BUILDING INSPECTION PERMIT

This is to certify that HOAG THOMAS D & ELIZABETH A HOAG JTS/Joe Luc
has permission to Renovate attic for bedroom/bathroom at new owner
AT 128 BRENTWOOD ST 179 H027001

128 Brentwood St.
Staff Review Checklist

Plans for:
 Tom Hoag and Liz Coomb
 128 Brentwood St.
 Portland, ME 04103

128 Brentwood Street
Portland, Maine

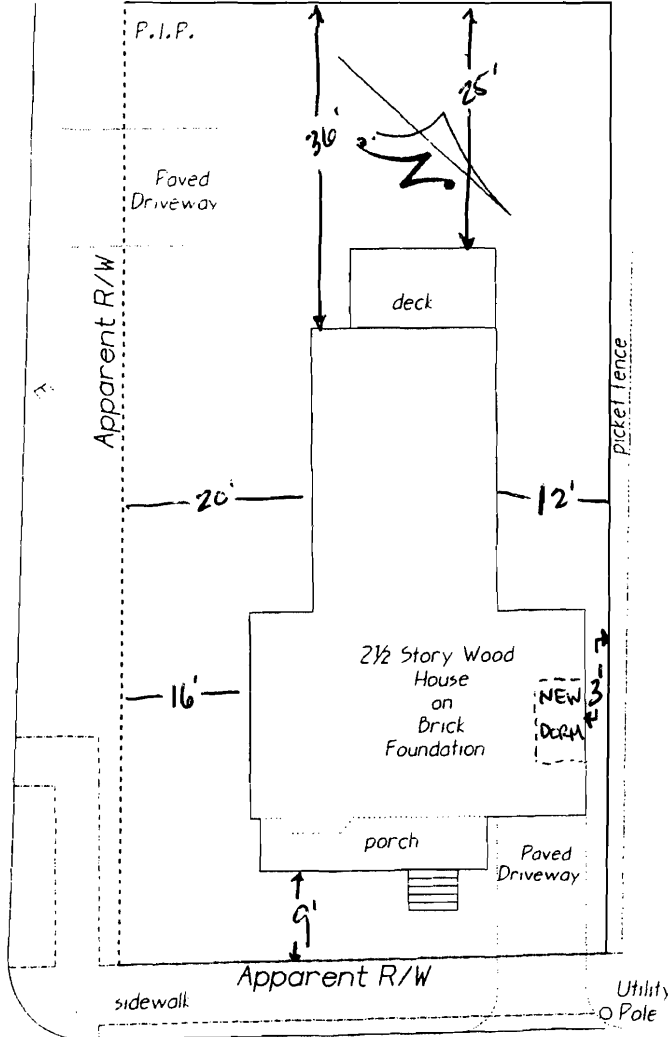
lot size = 5,200 sq ft
land area per du 6,500 sq ft
front 25' min - 9'
rear 25' min - 25'
side 2 14' - 3 1/2 16'

needs section 14-436 (a)
50% = 743.5 sq ft
addition 56 sq ft

FRAMING ELEVATION

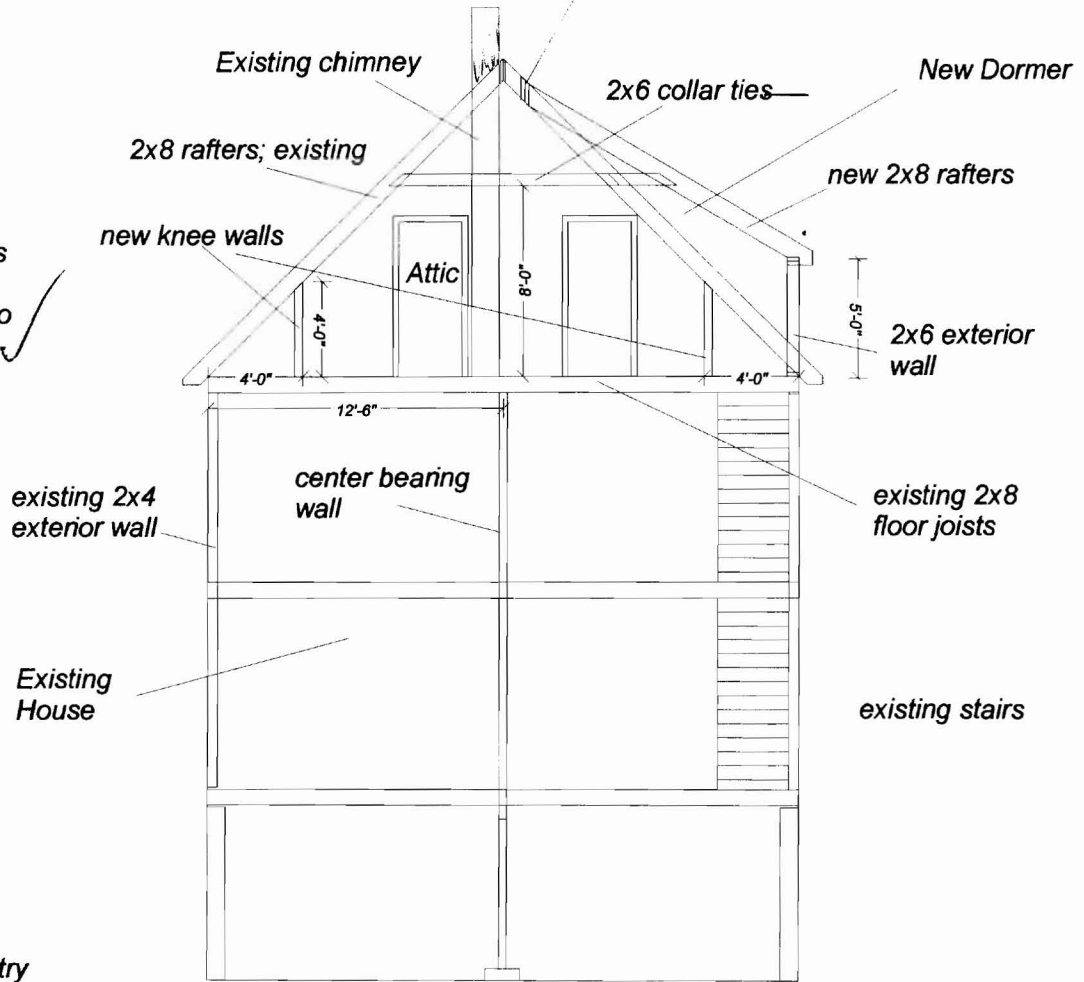
dormer = 14'
 adding 14 x 4 = 56 sq ft
 8% of allowable increase.

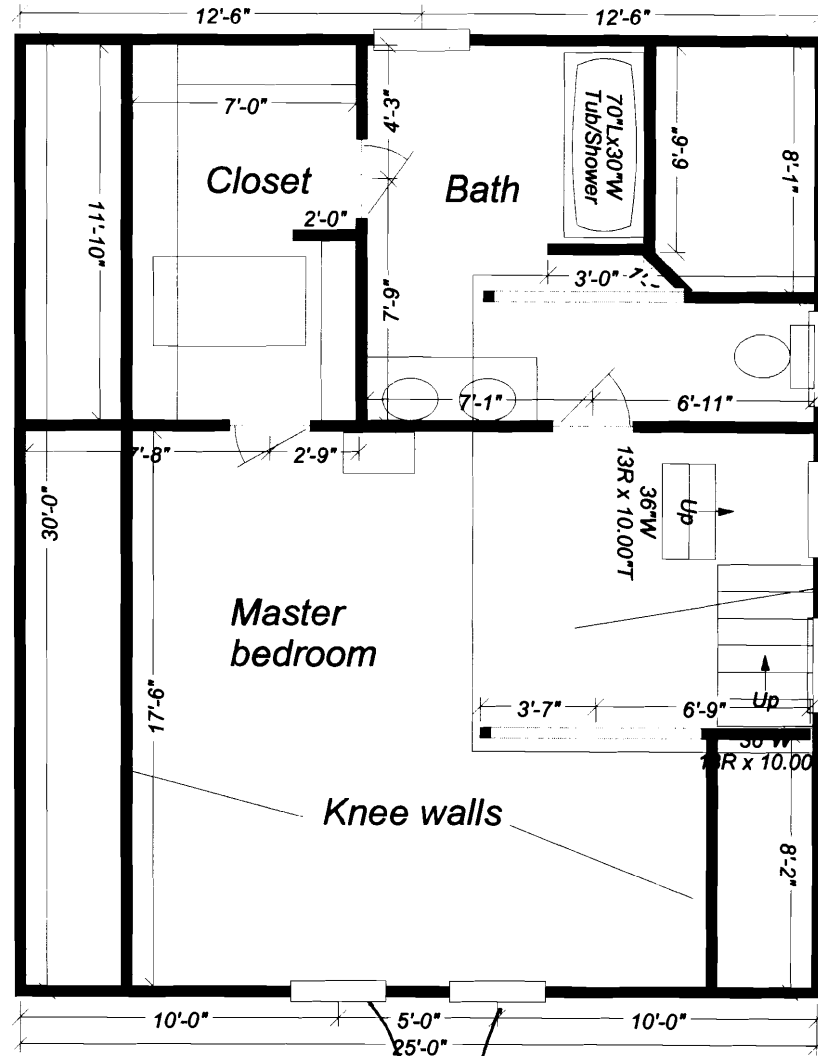
Window will be at
30" elevation to
be higher than
back of toilet

Tempered (?)
